# MDS-JA3ES

## SUPPLEMENT-2

- Subject :**
1. CORRECTION
  2. CHANGE OF OVER WRITE HEAD
  3. CHANGE OF MECHANISM DECK
  4. BOARD CHANGED
  5. PARTS CHANGED

(ECN-CD501853)

6-4. MECHANISM SECTION (MDM-2C)

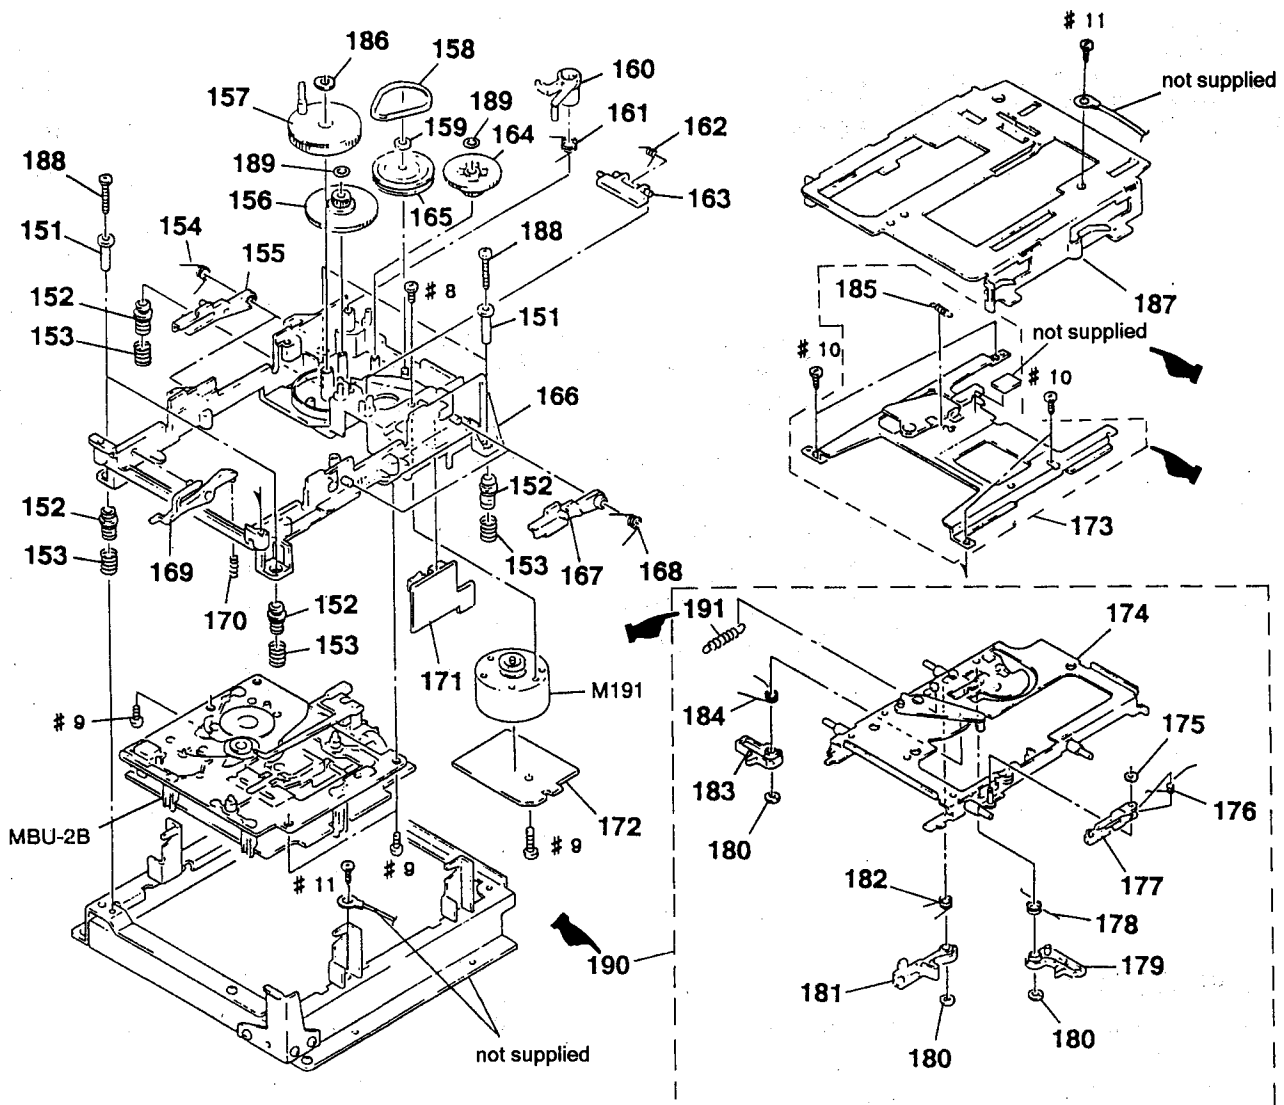
- Correct your service manual as shown below.
- : Indicated corrected portion

(Page 87)

Ref.No.	Part No.	Description	Remark	Ref.No.	Part No.	Description	Remark
151	4-983-100-01	COLLAR (DAMPER)	■	* 172	1-653-412-11	MOTOR BOARD	
152	4-967-671-01	INSULATOR (MD)		173	A-4660-647-B	BRACKET (LVO) ASSY	
153	4-967-673-01	SPRING, COMPRESSION	■	* 174	X-4946-378-1	HOLDER ASSY	
154	4-967-668-01	SPRING (UDL), TORSION		175	4-968-919-11	WASHER, STOPPER	
155	4-967-667-01	LEVER (UDL)		176	4-967-646-01	SPRING (SHT), TORSION	
156	4-967-655-01	GEAR (BD-B)		177	4-967-645-01	LEVER (SHT)	
157	X-4945-069-1	CAM ASSY		178	4-977-450-01	SPRING (LM), TORSION	
158	4-967-656-01	BELT (BD)		179	4-967-639-01	LEVER (LM)	
159	4-968-919-31	WASHER, STOPPER		180	4-968-919-01	WASHER, STOPPER	
160	4-967-637-01	LEVER (SLM)		181	4-967-641-01	LEVER (L)	
161	4-967-638-01	SPRING (SLM), TORSION		182	4-967-642-01	SPRING (L), TORSION	
162	4-968-273-01	SPRING (OWH), TORSION		183	4-967-643-01	LEVER (LS)	
163	4-968-272-01	LEVER (OWH)		184	4-967-644-01	SPRING (LS), TORSION

164	4-967-654-01	GEAR (BD-A)	■	185	4-967-664-01	SPRING, TENSION	
165	4-957-794-01	PULLEY (GEAR 1)		186	4-968-919-21	WASHER, STOPPER	
* 166	X-4945-068-1	BASE (BD) ASSY		* 187	X-4946-349-1	SLIDER (M) ASSY	
167	4-967-669-01	LEVER (UDR)		188	4-972-910-01	SCREW (2.6X18), +B	
168	4-967-670-01	SPRING (UDR), TORSION		189	4-968-919-41	WASHER, STOPPER	
169	4-967-657-01	LEVER (DOOR)	■	190	A-4660-953-B	HOLDER, COMPLETE ASSY	
170	4-970-710-01	SPRING, COMPRESSION		191	4-971-743-02	SPRING, TENSION

* 171	1-653-411-11	DETECTION SW BOARD	■	M191	A-4660-646-A	MOTOR ASSY (LOADING)

### Difference table

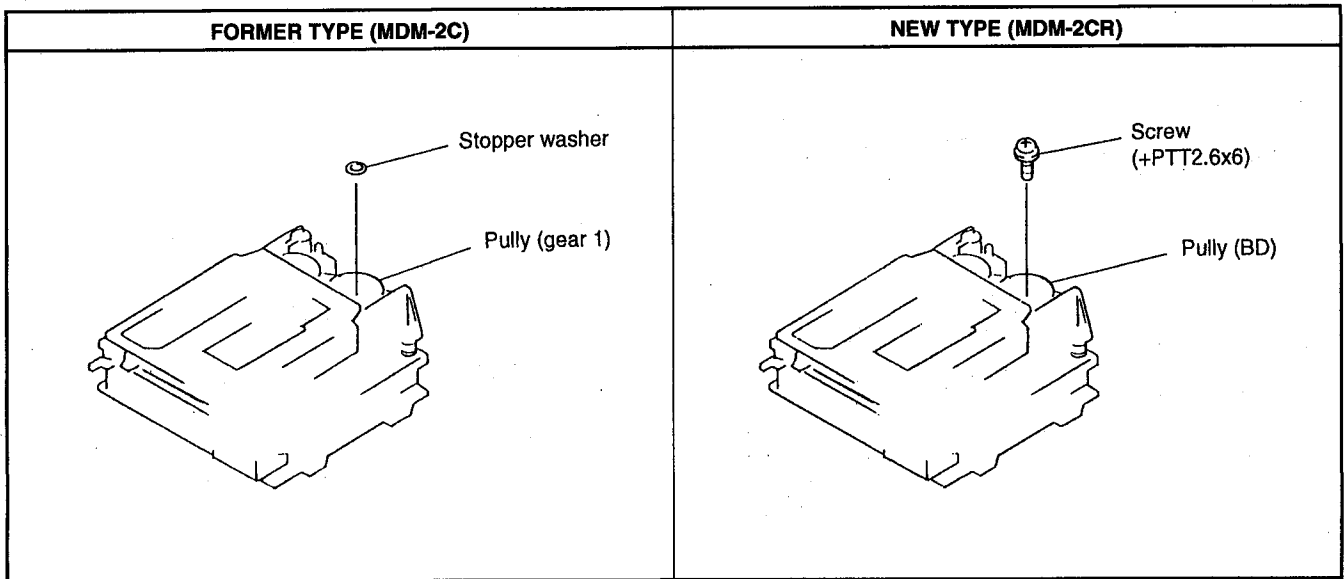
The over write head has changed.

According to the change, the service form will be changed, so refer to "How to discriminate (Over write head)"

FORMER TYPE				NEW TYPE			
Ref.No.	Part No.	Description	Remark	Ref.No.	Part No.	Description	Remark
203	1-654-446-11	FLEXIBLE BOARD (OWH)				not used	
HR901	1-500-175-11	HEAD, OVER WRITE (RF322-74A)		HR901	1-500-304-21	HEAD, OVER WRITE

\* The new part can be used instead of the former over write head.

Page	FORMER	NEW
39	<p>Location: A, 4-6</p>	<p>Location: A, 4-6</p>
41	<p>Location: B-C, 2-4</p> <p><b>OPTICAL PICK-UP BLOCK (KMS-210A/J-N)</b></p>	<p>Location: B-C, 2-4</p> <p><b>OPTICAL PICK-UP BLOCK (KMS-210A/J-N)</b></p>

**MECHANISM SECTION (MDM-2CR)**

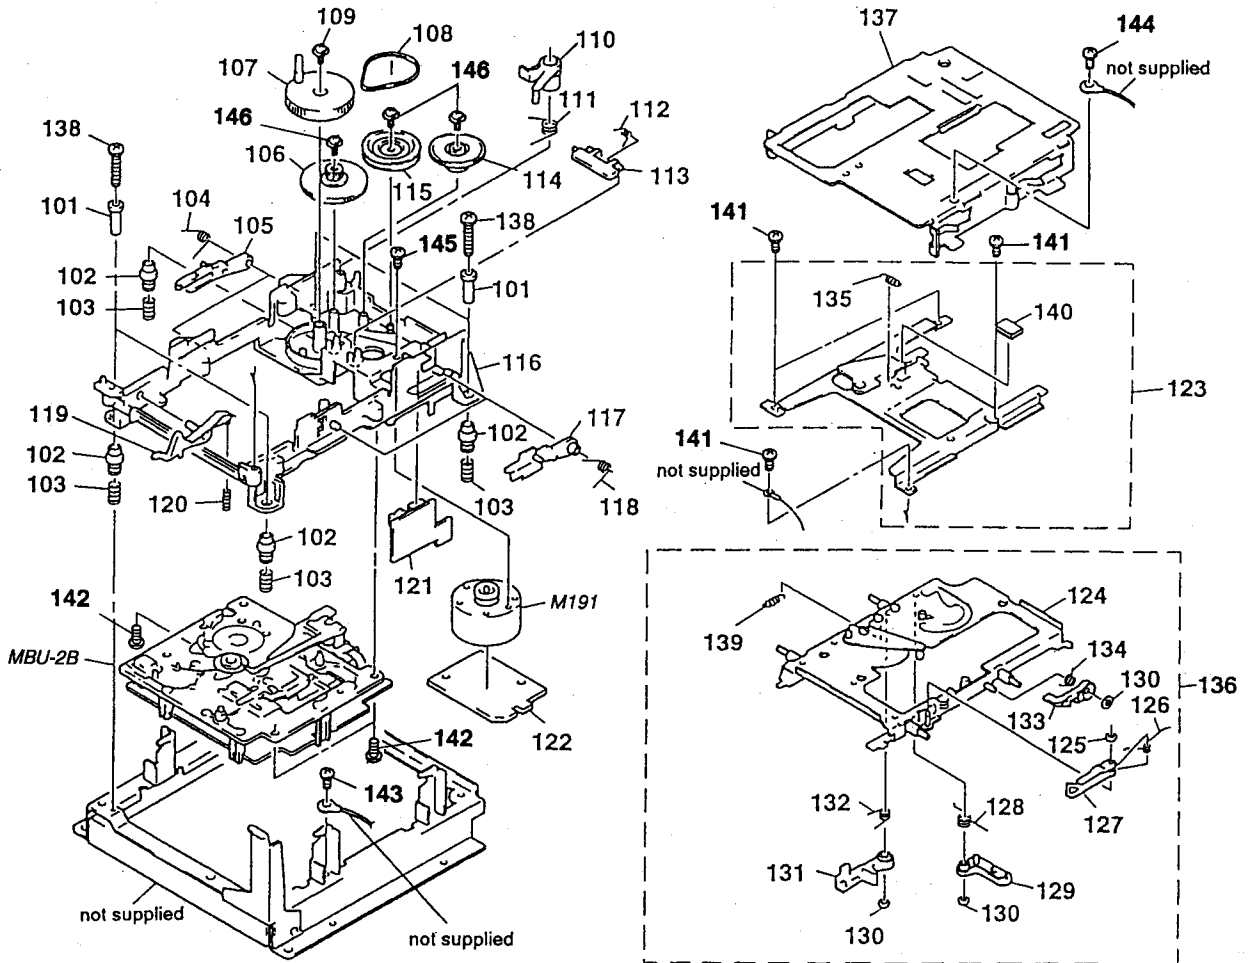
The mechanism deck has been changed from MDM-2C to MDM-2CR.

Refer to "How to discriminate (Mechanism deck)" so that there is no interchangeability between MDM-2C to MDM-2CR.

Ref. No.	Part No.	Description	Remark	Ref. No.	Part No.	Description	Remark
101	4-983-100-01	COLLAR (DAMPER)		125	4-968-919-11	WASHER, STOPPER	
102	4-967-671-01	INSULATOR (MD)		126	4-967-646-01	SPRING (SHT), TORSION	
103	4-967-673-01	SPRING, COMPRESSION		127	4-967-645-01	LEVER (SHT)	
104	4-967-668-01	SPRING (UDL), TORSION		128	4-983-106-02	SPRING (LM), TORSION	
105	4-967-667-01	LEVER (UDL)		129	4-967-639-01	LEVER (LM)	
106	4-977-610-01	GEAR (BD-B)		130	4-968-919-01	WASHER, STOPPER	
107	X-4945-069-1	CAM ASSY		131	4-967-641-01	LEVER (L)	
108	4-967-656-01	BELT (BD)		132	4-967-642-01	SPRING (L), TORSION	
109	4-933-134-01	SCREW (+PTPWH M2. 6X6)		133	4-982-040-01	LEVER (LOCK)	
110	4-967-637-01	LEVER (SLM)		134	4-982-099-01	SPRING (LOCK), TORSION	
111	4-984-426-01	SPRING (SLM), TORSION		135	4-967-664-05	SPRING, TENSION	
112	4-968-273-01	SPRING (OWH), TORSION		136	A-4672-071-B	HOLDER COMPLETE ASSY	
113	4-968-272-01	LEVER (OWH)		* 137	X-4946-349-1	SLIDER (M) ASSY

114	4-977-609-01	GEAR (BD-A)		138	4-972-910-01	SCREW (2. 6X18), +B	
115	4-977-608-01	PULLEY (BD)		139	4-971-743-02	SPRING, TENSION	
116	4-977-777-01	BASE (BD)		140	4-983-110-01	CUSHION (LVO)	
117	4-967-669-01	LEVER (UDR)		141	7-685-104-19	SCREW +P 2X6 TYPE2 NON-SLIT	
118	4-967-670-01	SPRING (UDR), TORSION		142	7-685-645-79	SCREW +BVTP 3X6 TYPE2 N-S	
119	4-979-400-01	LEVER (DOOR)		143	7-621-773-86	SCREW +BVTT 2. 6X4 (S)	
120	4-970-710-01	SPRING, COMPRESSION		144	7-621-255-25	SCREW +PTT 2X4 (S)

* 121	1-653-411-11	DETECTION SW BOARD		145	7-621-775-20	SCREW +B 2. 6X5	
* 122	1-653-412-11	MOTOR BOARD		146	7-621-770-67	SCREW +PTT 2. 6X6 (S)	
123	A-4672-087-A	BRACKET (LVO) ASSY		M191	A-4660-646-A	MOTOR (LOADING) ASSY (MD)	
124	X-4947-136-2	HOLDER ASSY

### DIGITAL board change

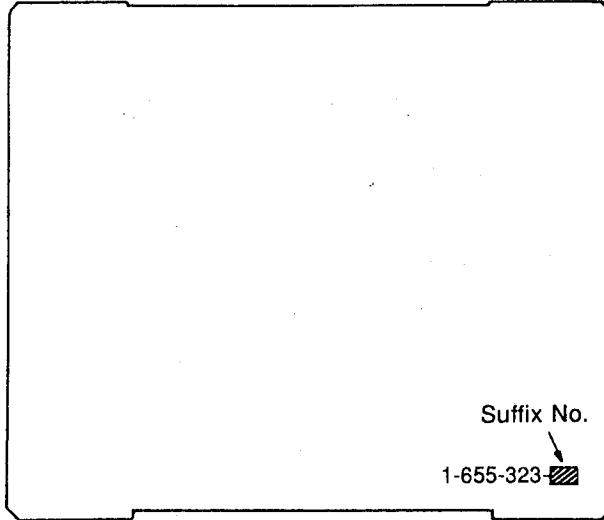
**Note :** There is no interchangeability in some mounting parts of boards which have a suffix No. -**14** or later and a suffix No. -**13** or before. The differences are shown as below.

**Note :** The using parts will be changed as shown in the table above according to using X851. Perform the replacement referring to the external appearance of X851.

Ref No.	FORMER Suffix No. - <b>13</b> or before			NEW Suffix No. - <b>14</b> or later		
	Part No.	Description	Remark	Part No.	Description	Remark
C250	1-163-038-00	CERAMIC CHIP 0.1uF 25V				
C251	1-163-038-00	CERAMIC CHIP 0.1uF 25V				
C851	1-163-227-11	CERAMIC CHIP 10PF 0.5PF 50V		1-163-087-00	CERAMIC CHIP 47PF 0.25PF 50V	
C852	1-163-227-11	CERAMIC CHIP 10PF 0.5PF 50V		1-163-087-00	CERAMIC CHIP 47PF 0.25PF 50V	
IC205	8-759-344-74	IC CXD8504M		8-759-344-63	IC CXD8504M-T6	
R851	1-216-066-00	METAL CHIP 5.1K 5% 1/10W		1-216-063-00	METAL CHIP 3.9K 5% 1/10W	
R852				1-216-033-00	METALGLAZE 220 5% 1/10W	
X851	1-579-069-11	VIBRATOR, CRYSTAL (49.152MHz)		1-579-971-11	VIBRATOR, CRYSTAL (49.152MHz)

**Changed portion**

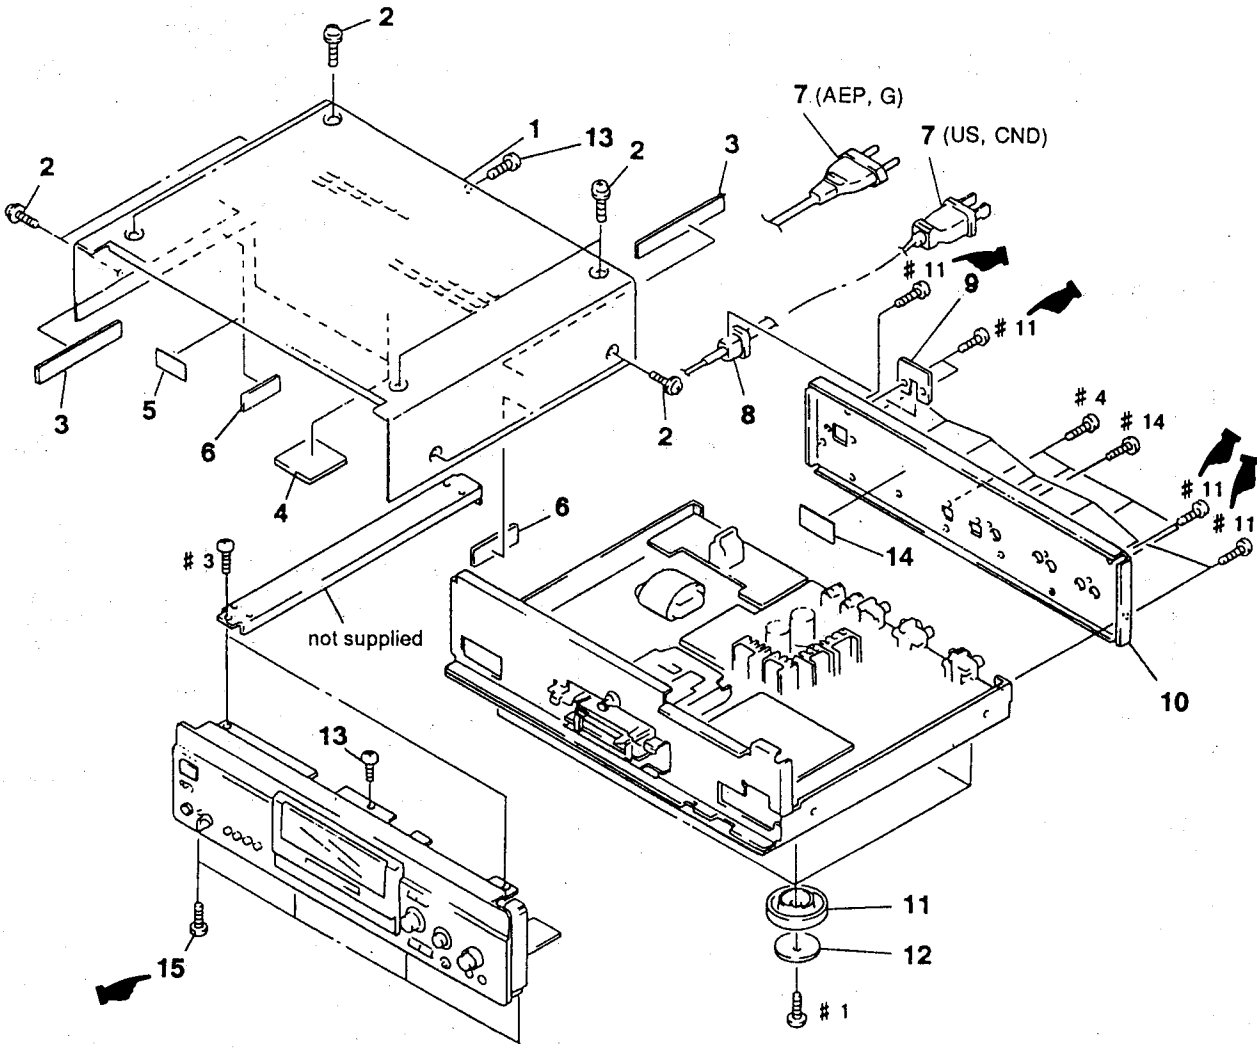
**Note :** The suffix No. of DIGITAL board has changed to -14, only differences compared with suffix No. -13 are mentioned in the following table.

As for the contents not mentioned here. refer to this table together with the service manual supplement-1 (9-960-228-82)

Page	FORMER Suffix No. -13 or before	NEW Suffix No. -14 or later
14	<p><b>[DIGITAL BOARD]</b> Location : M-N, 26-27</p>	
15	<p><b>[DIGITAL BOARD] (SIDE A)</b> Location : E-F, 4-5</p> <p style="text-align: right;">1-655-323-<span style="border: 1px solid black; padding: 2px;">13</span></p>	<p style="text-align: right;">1-655-323-<span style="border: 1px solid black; padding: 2px;">14</span></p>
18	<p><b>[DIGITAL BOARD] (SIDE B)</b> Location : E-F, 17-18</p> <p style="text-align: right;">1-655-323-<span style="border: 1px solid black; padding: 2px;">13</span></p>	<p style="text-align: right;">1-655-323-<span style="border: 1px solid black; padding: 2px;">14</span></p>
